Amendments/Additional Information

Cottage one, Dunsley Hall – ref NYM/2017/0016/FL

COTTAGE ONE DUNSLEY
AS BUILT BOILER ROOM/
GARDEN STORE Scale 1:75

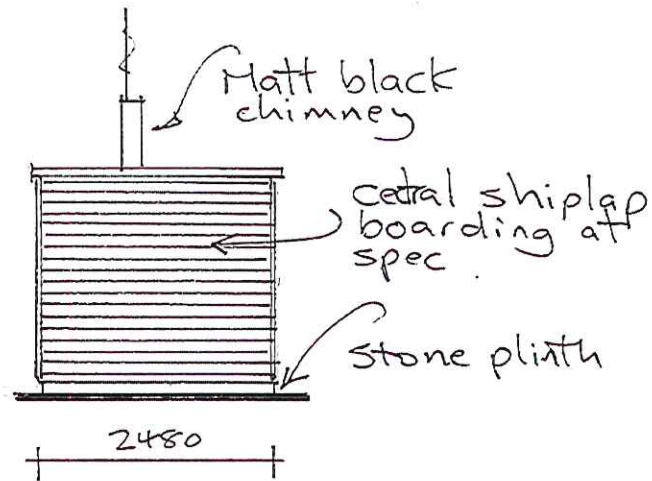
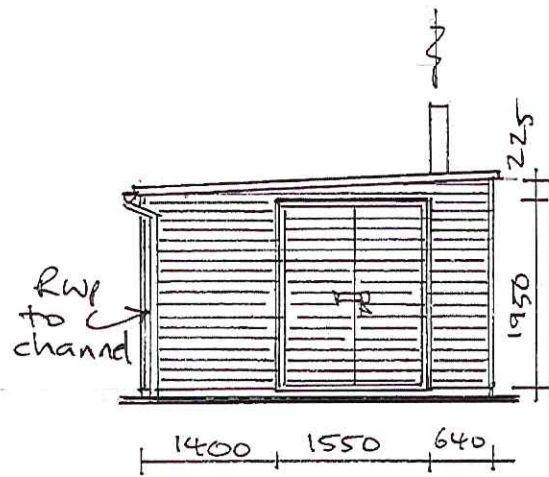
I attach amended details of the boiler room/ garden store with dimensions.

The references on drawings to 'decking omitted' is purely for elevational clarity reasons, as is surely evident by the fact the decking is clearly shown on plan and side elevation.

With regard to lowering the level of the decking, my Client is insistent that planning consent exists with the decking shown at or around the floor level to the extension on original and revised drawings.
